P/N: 11618-06517

CUSTOMER NAME		W.O. #	
Captive Socket Head Cap Screw		ORDER #	
Date Issued 2/09/15		Job #	
Part # 4823-M07-F09		David	
Material STAINLESS STEEL		Promised Date 0/00/00	
Diameter 0.303 - 0.312		Amount to Make	
		Finish NO FINISH

Subject: Re: P5121032050PSS (11618-06517) 10-32X0.50",SOC.HD SS CAPTIVE

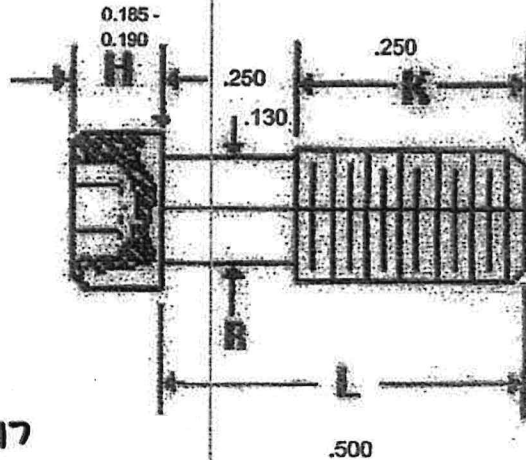
Plunge Grind .130 Tolerance + / - .005

This Print is good.

Please Quote 50K PCS.

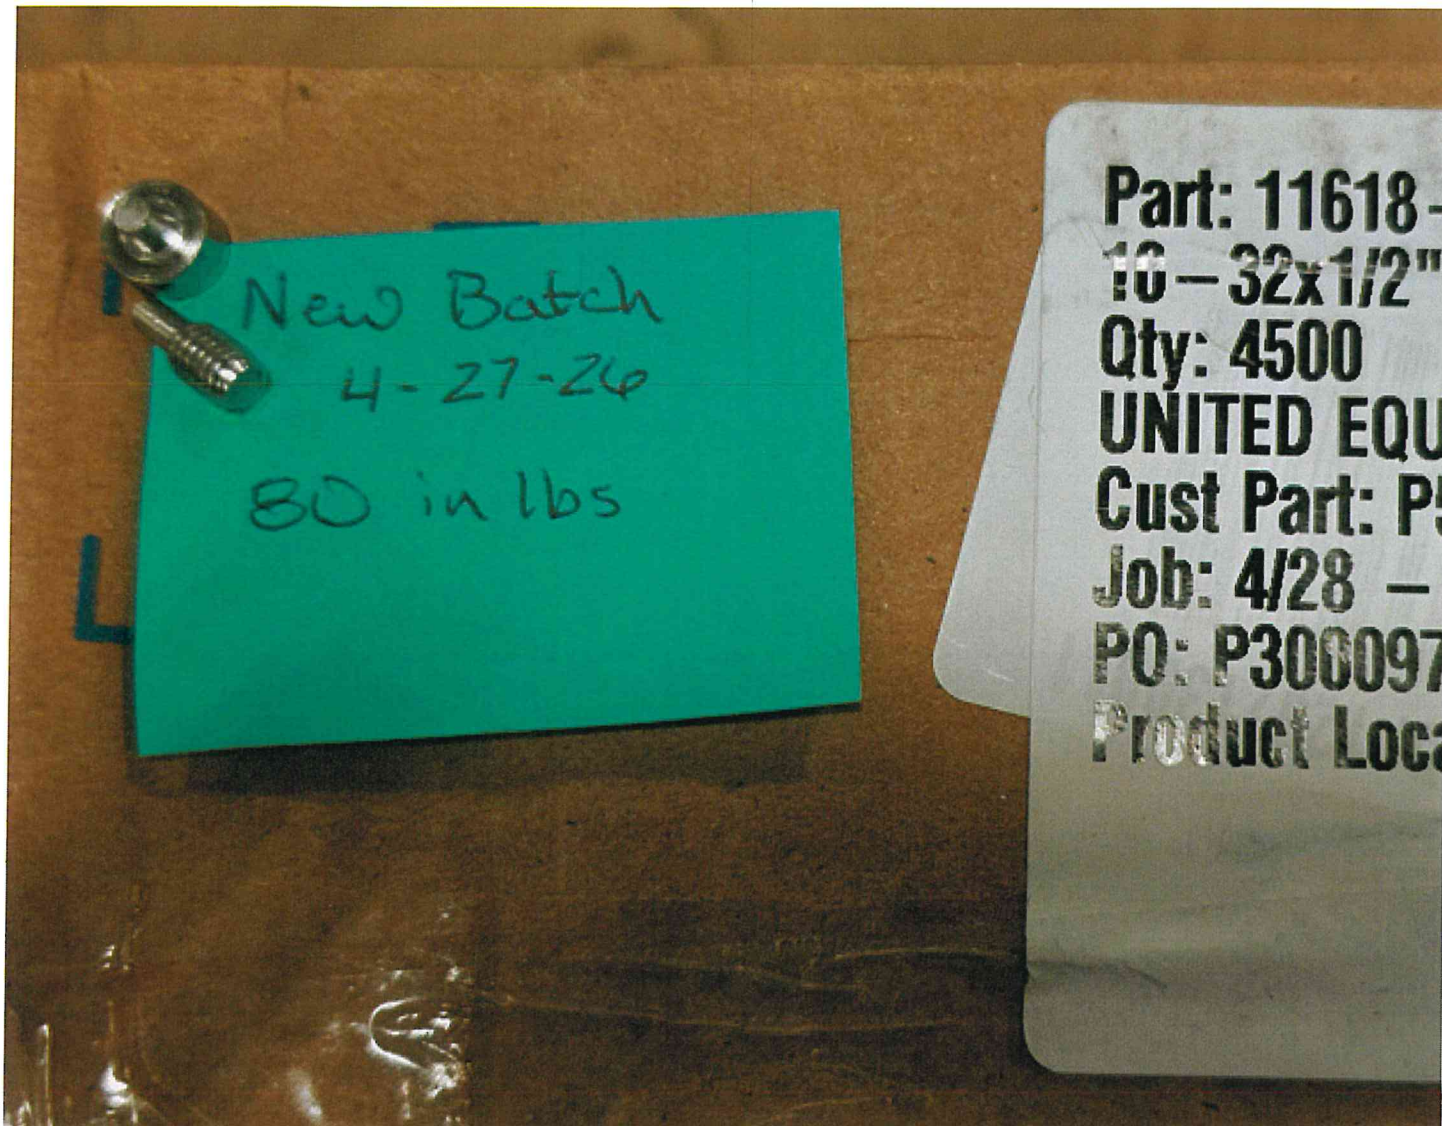
We just performed a quick test of the fasteners from two different boxes and could not come even close to the manufacturers stated value of "135 in-lbs. of torque and the screw was twisting below the head". I'm not sure what method was used to get this. We just quick double jam nut them at the base of the threads. Then used a torque wrench and found that the older box from PO# P300095231 twisted and brock at 55 in-lbs. The newer box cleanly just snapped at 80 in-lbs. See the images below. This was performed with a calibrated tool.

Was their measurement from the head of the fastener being seated to a surface (tightened down) or a fixed thread position as we performed?

For our testing method, we applied two jam nuts at the base of the threads and locked them together. The screw was then secured in a vise at the jam nuts. Using a calibrated in-lb. torque wrench, we applied torque in 5 in-lb. increments until failure. Images of each test were previously provided.

- PO# P300095231 failed at 55 in-lbs (twisted and broke)
- PO# P300097118 failed at 80 in-lbs (clean snap)
